**Barber Manor Area Water Main Upgrades
ECUA BID NO. CC2024-03**

JANUARY 31, 2024

ADDENDUM NO. 3

Drawn:	DF
Designed:	MER
Checked:	MER
Date:	11/15/2023
Sheet No.	C-108

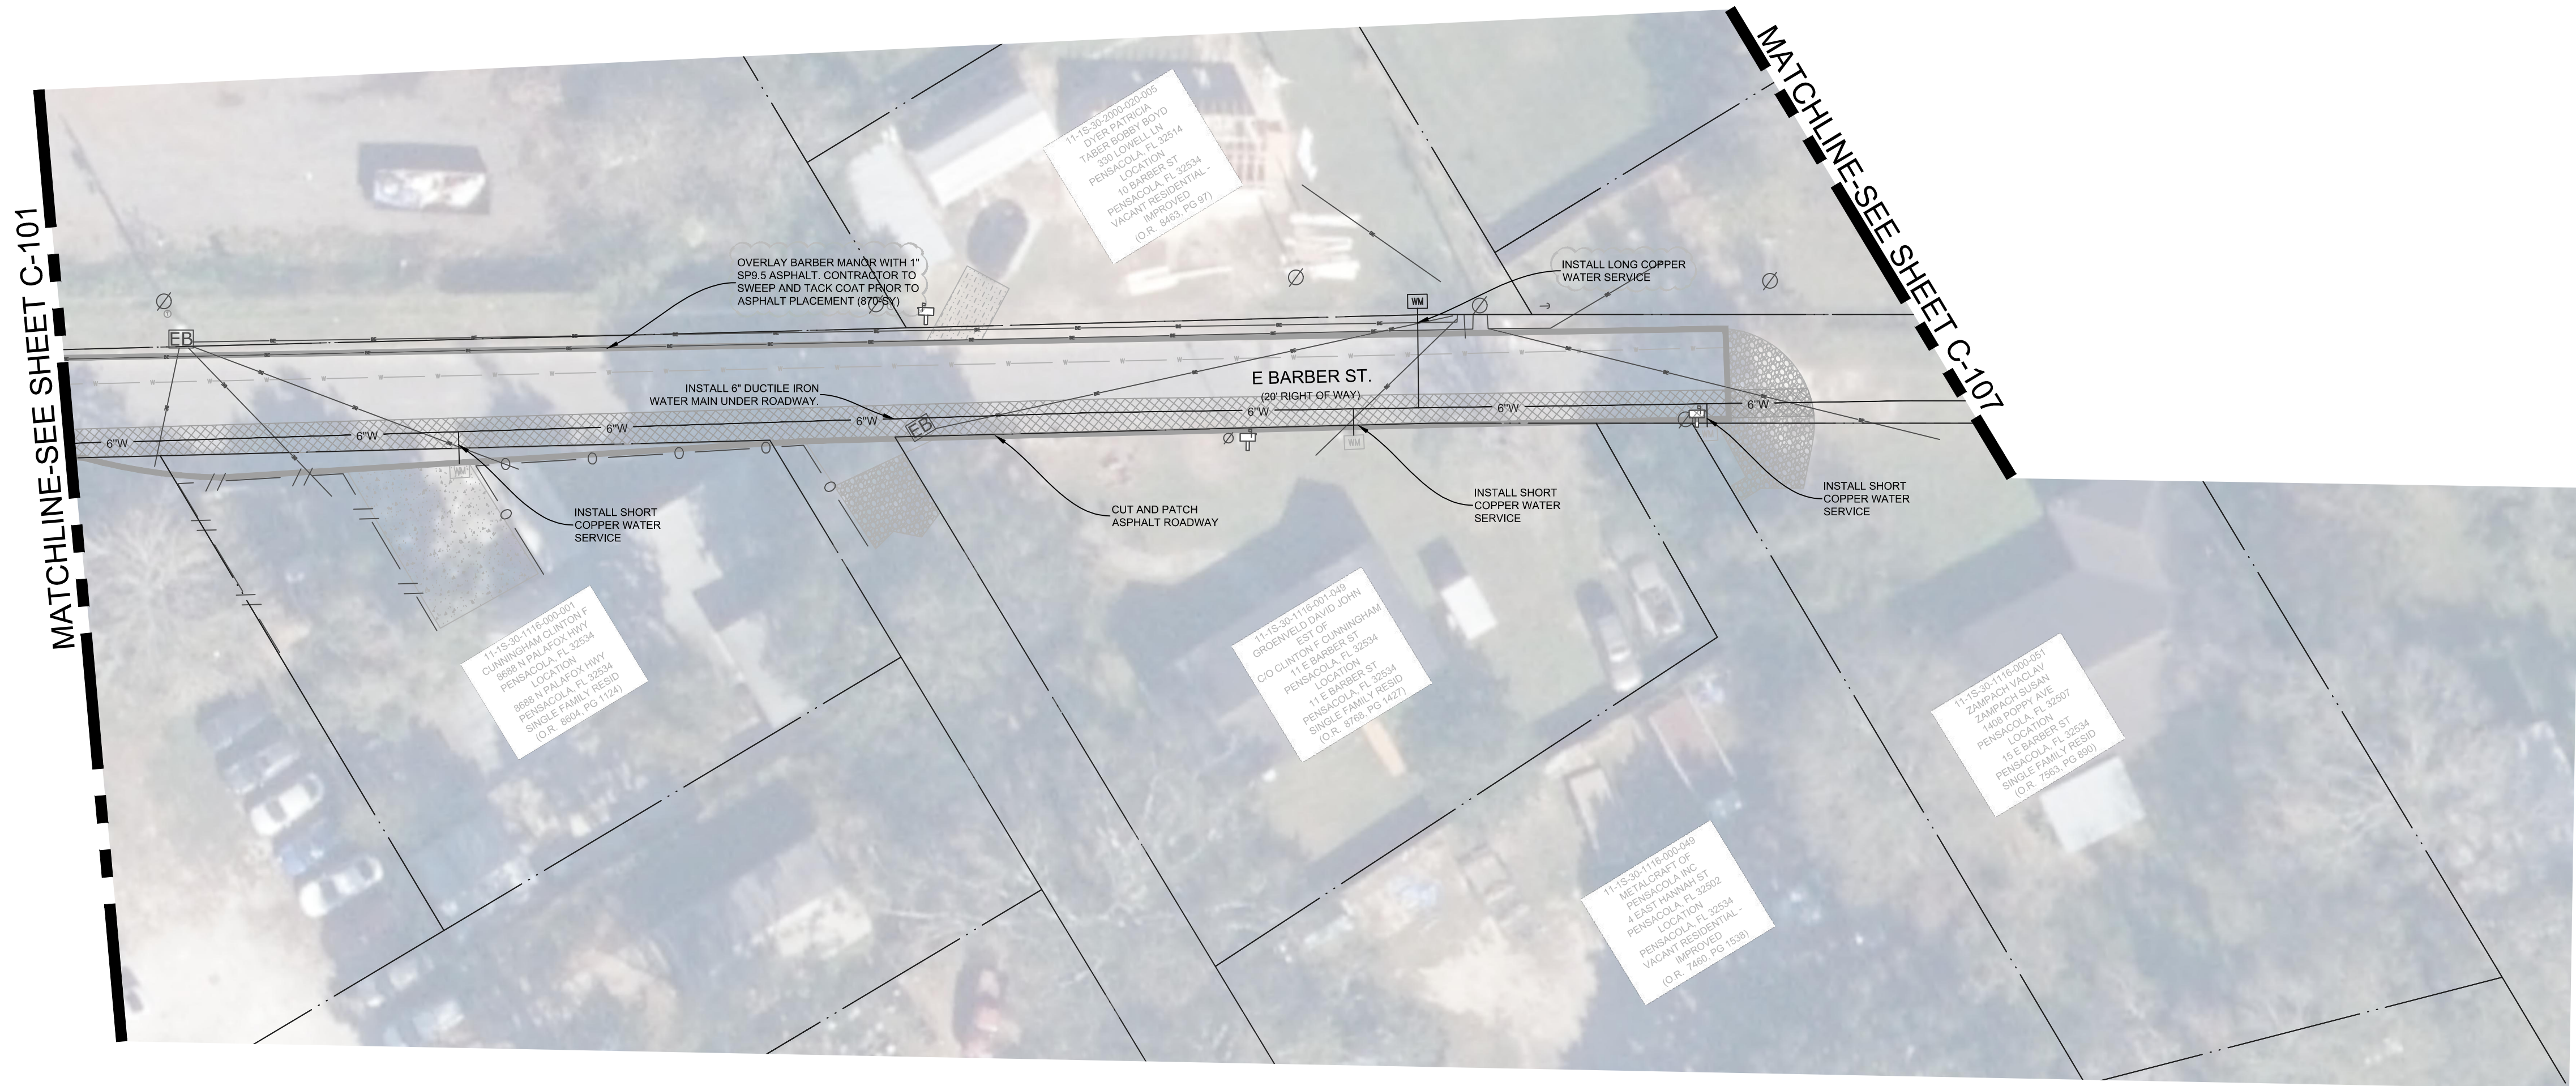
1. Sheet C-108 was modified to add a note for the overlay requirement of 1" SP9.5 on Barber Manor.
